# International Code Council

## **ICC A117.1-2015 edition** **Proposals received** **On the 2009 edition of the** **ICC A117.1 standard**

**For August 27-31, 2012 Meeting**

**A117.1 Proposed Change Matrix:  
July 27, 2012**

FIG. 306.3  
KNEE CLEARANCE

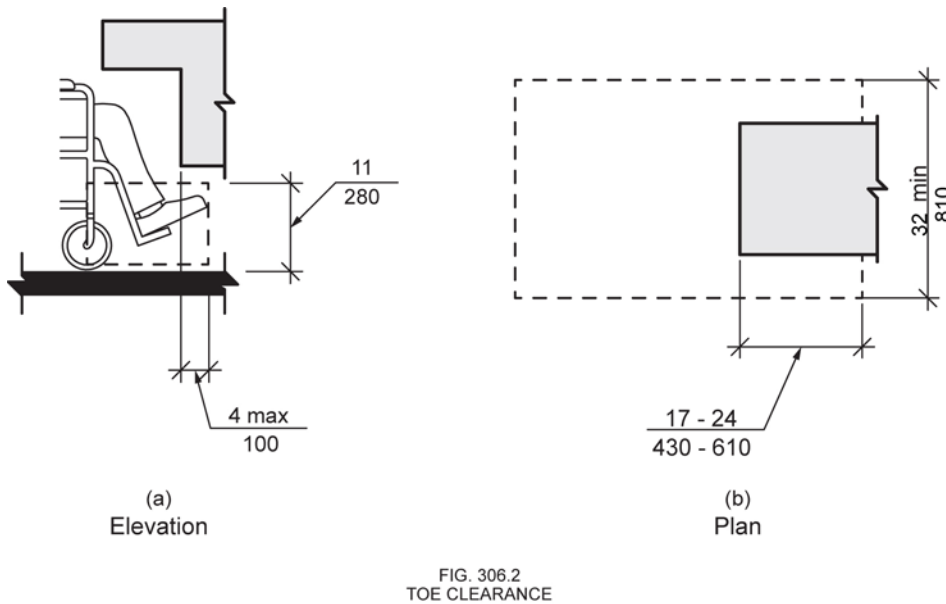
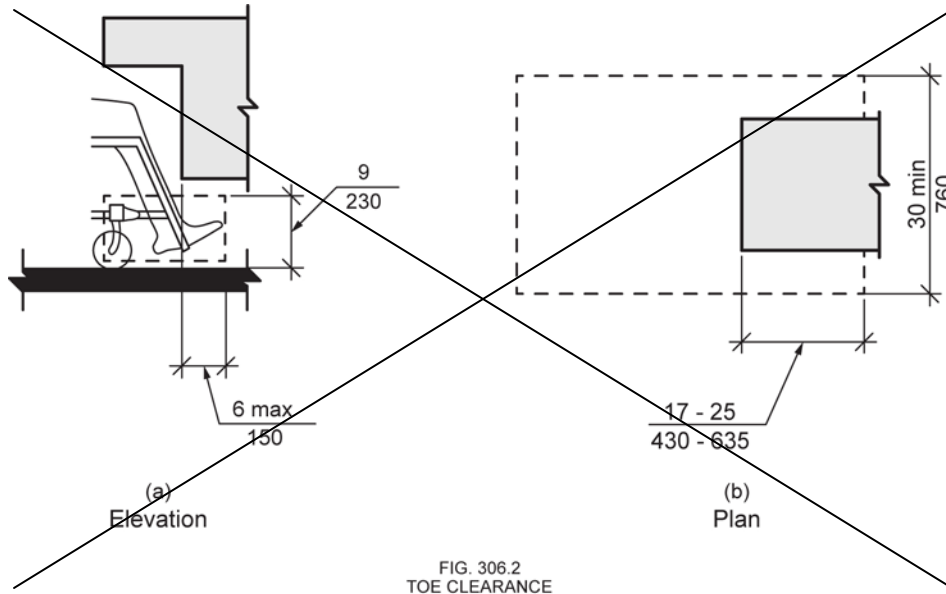
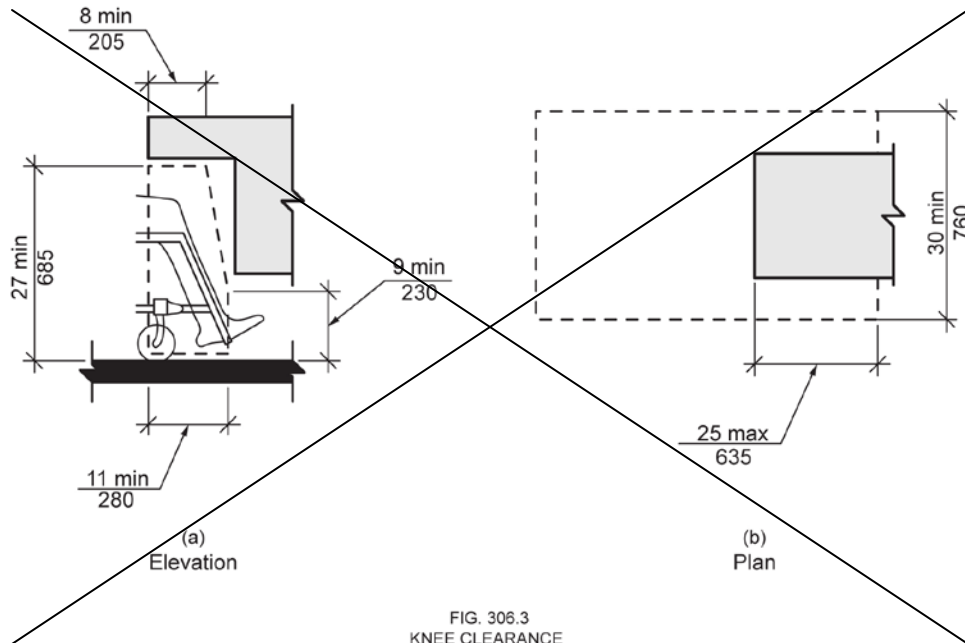
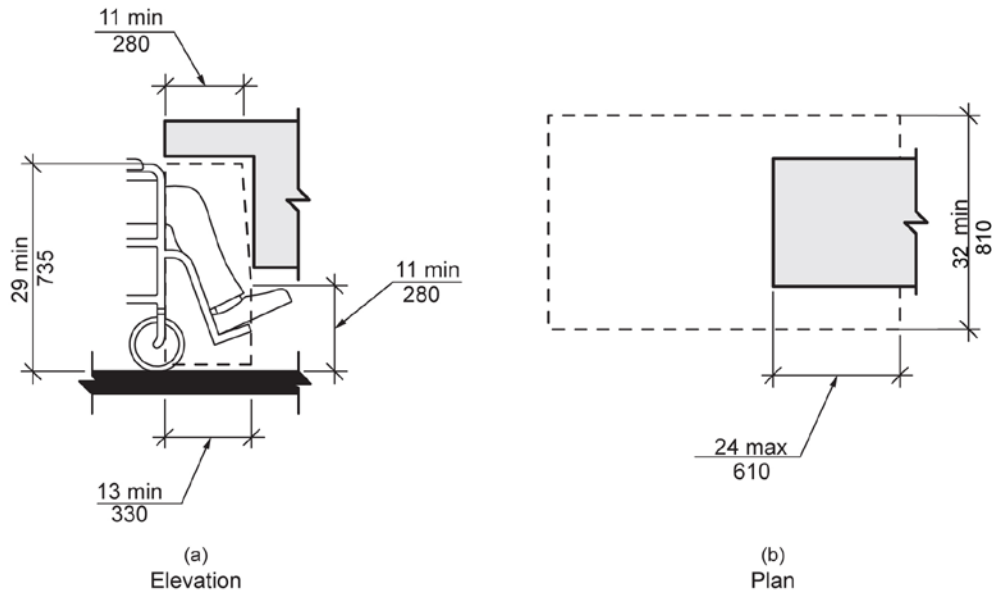
**306.3.1 General.** Space beneath an element between ~~9~~ 11 inches (~~230~~ 280 mm) and ~~27~~ 29 inches (~~685~~ 735 mm) above the floor shall be considered knee clearance and shall comply with Section 306.3.

**306.3.2 Maximum Depth.** Knee clearance shall be permitted to extend ~~25~~ 24 inches (~~635~~ 610 mm) maximum under an element at ~~9~~ 11 inches (~~230~~ 280 mm) above the floor.

NOTE: This change necessitates a change to Fig. 306.2 and Fig. 306.3 to ensure consistency. Thus, the proposed revised figures have been attached, along with the existing figures for comparison purposes.

### 308.2.1, Figure 308.2.1

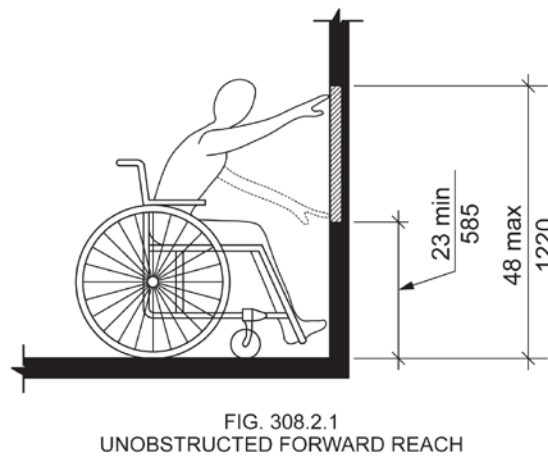
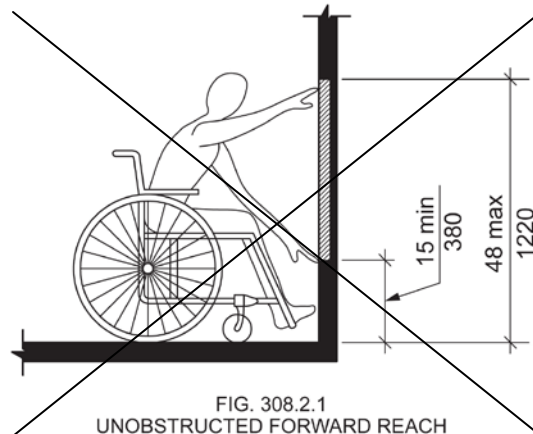
- 1) A substantial number of wheeled mobility users (about 15% of manual chair users and 42% of power chair users) did not possess any functional reach capability (defined as reaching and placing an empty canister above shoulder height), and
- 2) Of the remaining wheeled mobility users in our study that could perform the reach tests a large percentage could not reach beyond the most forward point of their device or foot. These percentages vary at different heights from the floor, and are also different for manual and power chair users. Figure 3-15 (pg. 68) in the Anthropometry of Wheeled Mobility (AWM) report (Steinfeld et al., 2010) summarizes these findings.

NOTE 2: This change necessitates a revision to Fig. 308.2.1 to ensure consistency. A revised figure is attached.

### 308.3.1, Figure 308.3.1

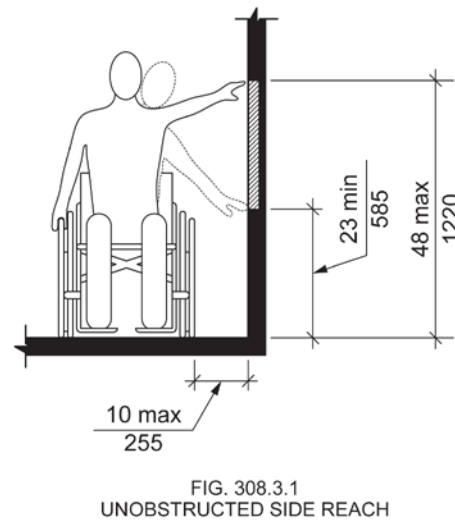
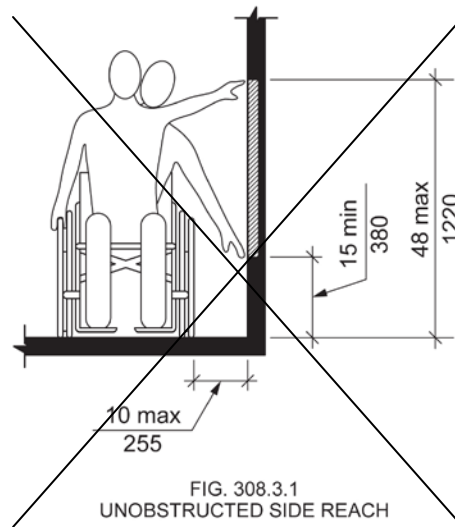
NOTE 2: This change necessitates a revision to Fig. 308.3.1 to ensure consistency. A revised figure is attached.

FIG. 404.2.2  
CLEAR WIDTH OF DOORWAYS

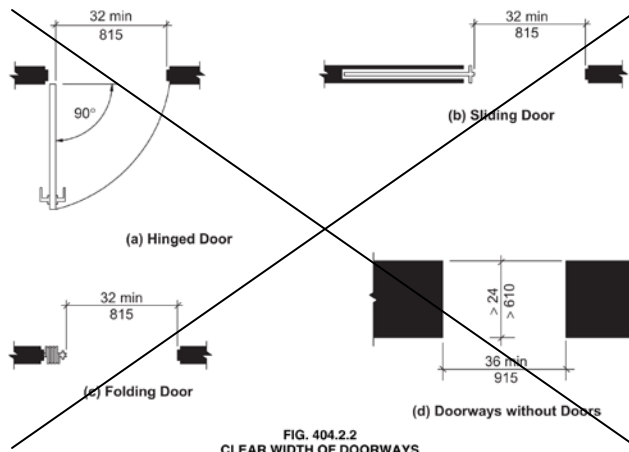
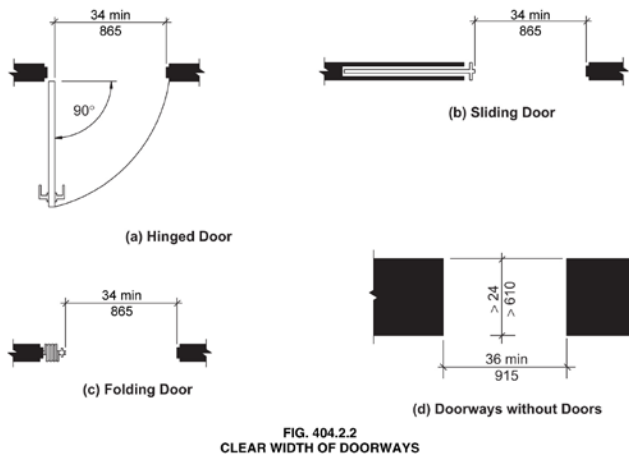
1. Door closers and door stops shall be permitted to be 78 inches (1980 mm) minimum above the floor.
2. In alterations, a projection of 5/8 inch (16 mm) maximum into the required clear opening width shall be permitted for the latch side stop.

**Reason:** Many of the technical requirements of the ICC/ANSI A117.1 (2009) Accessible and Usable Buildings and Facilities (ICC/ANSI) designed to accommodate wheeled mobility users are based on research completed from 1974 to 1978 using a research sample that included about 60 individuals who used manual wheelchairs (Steinfeld et al., 1979).

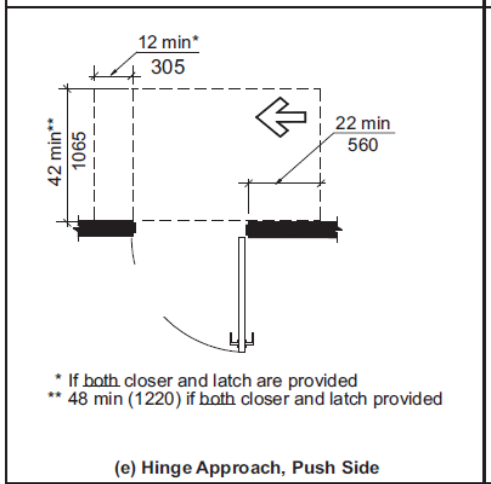
The A117.1 requires there 12 inches beyond the latch side on this door if both a closer and a latch are provided on the door. The ADA does not have this 12 inch requirement.

This requirement was added to the A117.1 standard between the 1998 and 2003 editions by proposal 4-015 and was modified by public comment that cleaned up the footnote reference for it. The proponent's reason statement said that figure (b) the front approach push side and figure (e) the hinge approach push side are similar situations and that having the 12 inches on the forward approach should also be provided on the hinge approach.

Because this extra requirement creates a discrepancy between the A117.1 and ADA which is not readily apparent and well known, the elimination of the footnote reference would help to coordinate the two standards and make this basic issue of door maneuvering clearances consistent. It seems that the addition of this requirement was probably not well justified when it was added into the 2003 A117.1 standard and with the change made in Section 404.2.3 of the 2009 edition which prevented door maneuvering clearances from including knee and toe clearance it made the difference between the A117.1 and the federal requirements that much greater. With some of the task groups looking at changing the 'building blocks' which could further affect maneuvering clearances, it would seem that this difference between the two standards should be eliminated or better justification should be provided so that it could be added into the federal requirements and coordinated that way.

The graphic representations of the various layouts are provided to better illustrate the differences. In the 2009 standard it is Fig 404.2.3.2(e) and in the 2010 ADA it is Figure 404.2.4.1(g). See ADA figure 404.2.4.1(f) for base condition.

FIG. 404.2.3.5  
MANEUVERING CLEARANCE AT RECESSED DOORS

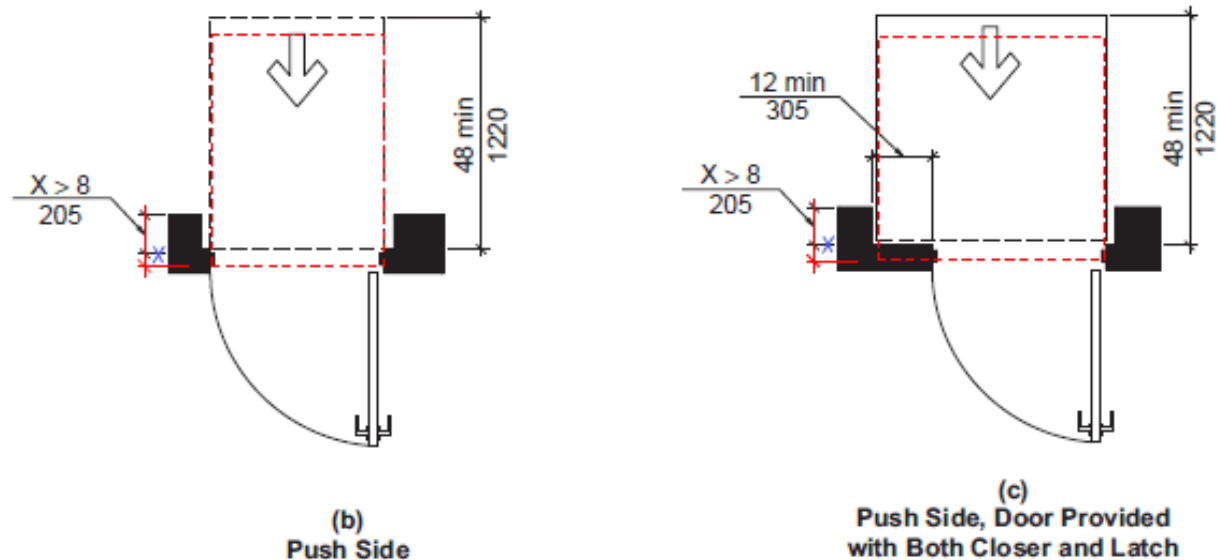
Door recess drawings are not correct. The text indicates that the recess is to be measured from the face of the door but the figures show in two cases the recess measured from the face of the frame.

**Revise as the Figure 404.2.3.5 (c) as follows:**

Fig. 404.2.5  
TWO DOORS IN A SERIES

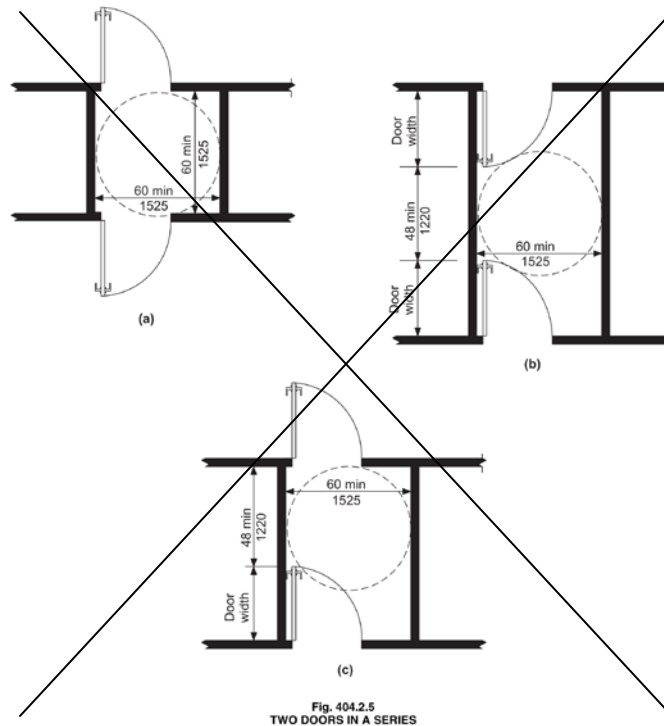
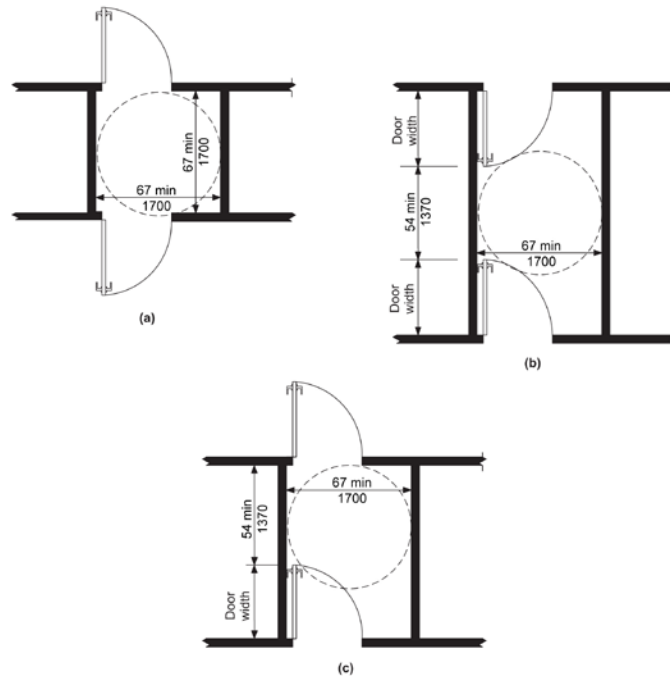
**404.2.5 Two Doors in a Series.** Distance between two hinged or pivoted doors in series shall be ~~48~~ **54** inches (~~1220~~ **1370** mm) minimum plus the width of any door swinging into the space. The space between the doors shall provide a turning space complying with Section 304.

### 604.4, Figure 604.4

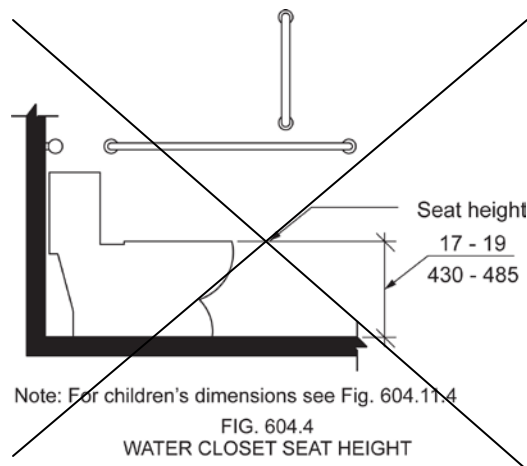
NOTE: This change necessitates a change to Fig. 604.4 to ensure consistency. Thus, the proposed revised figure has been attached, along with the existing figure for comparison purposes.

### 604.7, Figure 604.7

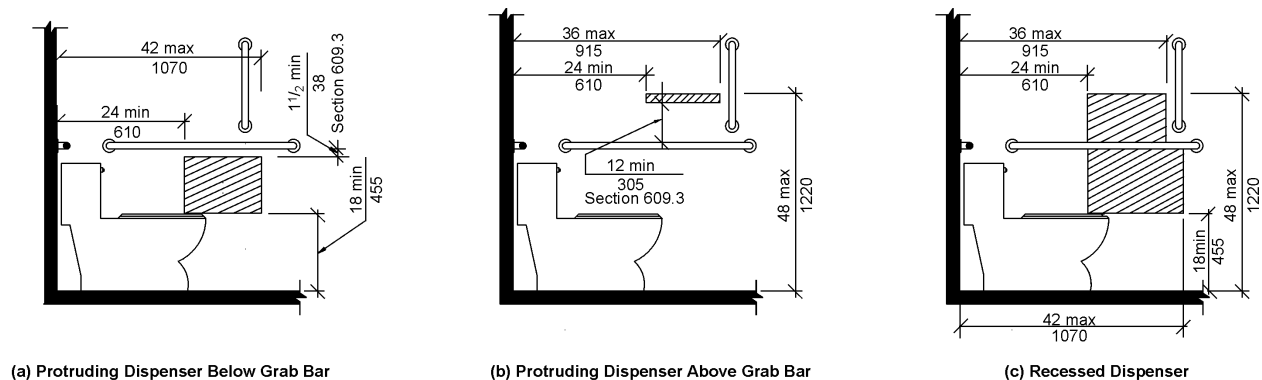
- Inconsistent with ICC A117.1- 2009 Section 3098.2 Forward Reach, 308.2.1 Unobstructed (Page 11), " low forward reach shall be 15 inches (380 mm) minimum"  
Figure 308.2.1 Unobstructed Forward Reach (Page 11), dimension call out "15 min (380 mm)"  
Section 308.3 Side Reach, 308.3.1 Unobstructed (Page 13, " low side reach shall be 15 min (380 mm)"

- Inconsistent with 2010 ADA Standards Section 604.7 Dispensers (page 201), "the outlet of the dispenser shall be 15 inches (380 mm) minimum"  
Figure 604.7 Dispenser Outlet Location (page 202), dimension call out "15 min (380 mm)"

### Table 604.9.3.1, Figure 604.9.3.1

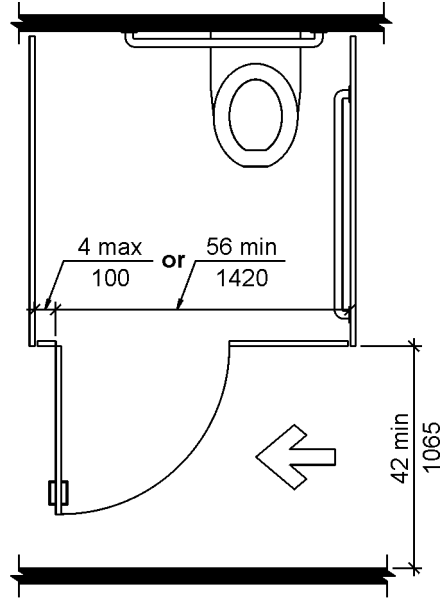
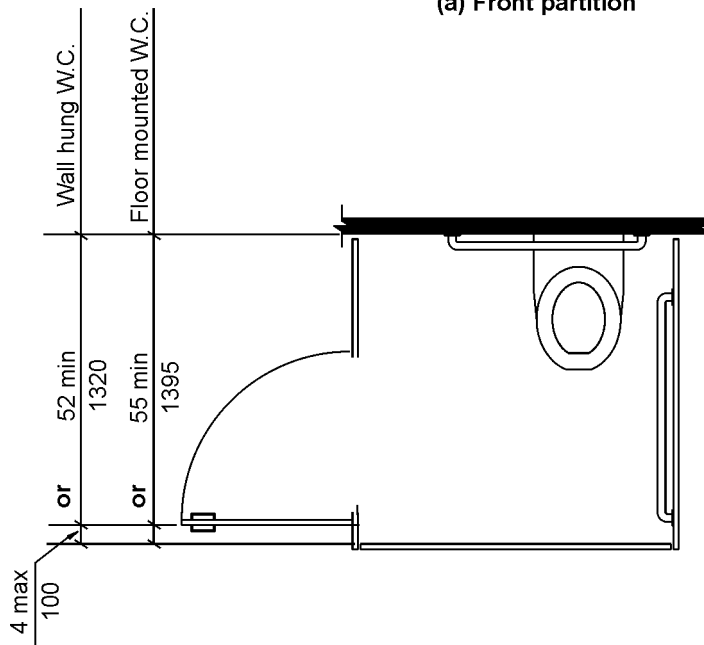
Change the called dimension for door opening location to read: 4 inches (100 mm) minimum to 6 inches (150mm) maximum.

## Figures 604.9.3.1 (a), (b), (c), Figure 604.9.5 (c)

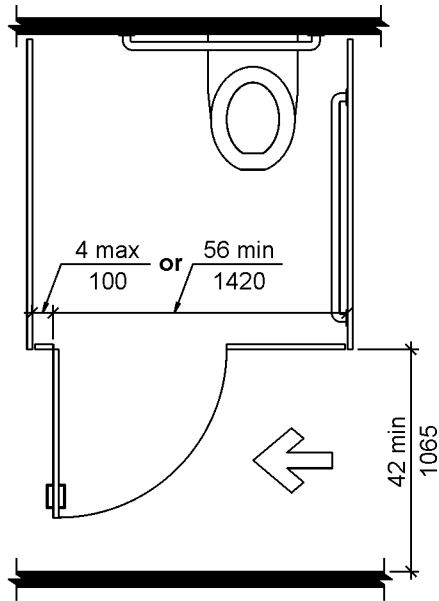
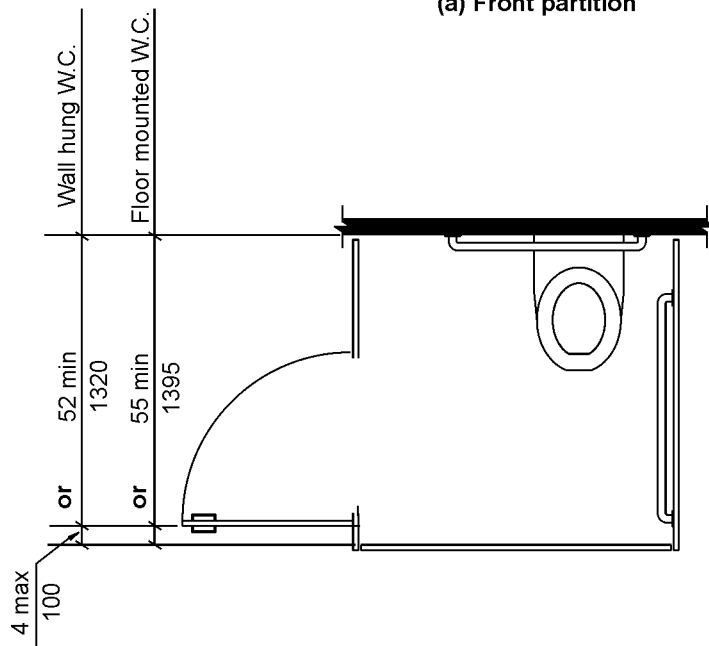
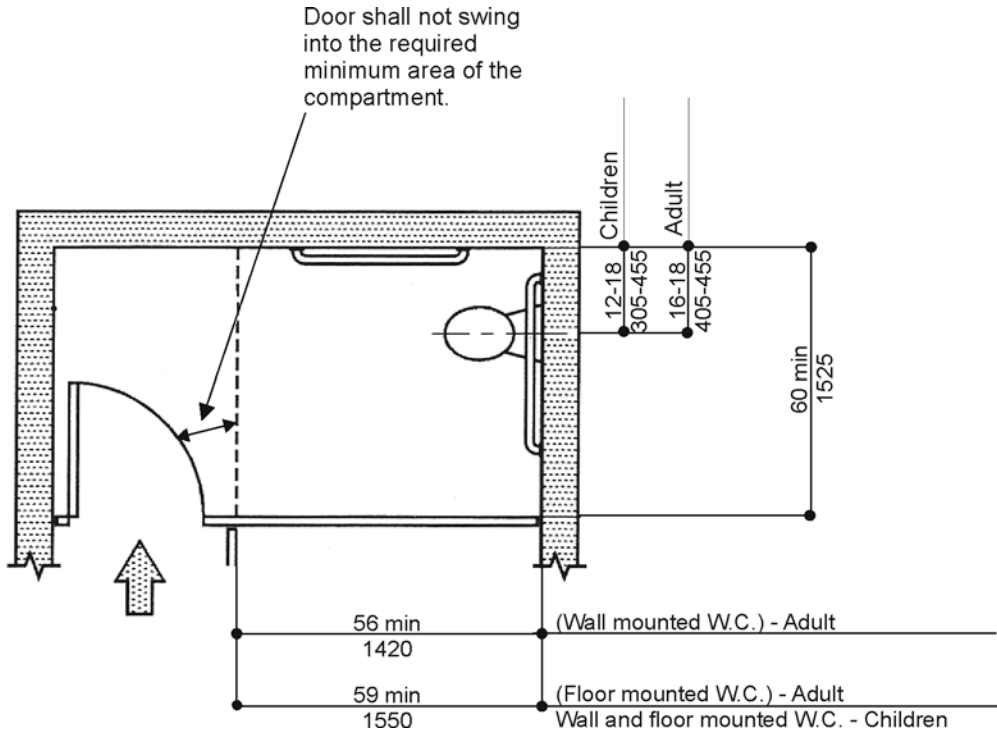
Revise each figure to indicate the placement of the vertical grab bar required for each.
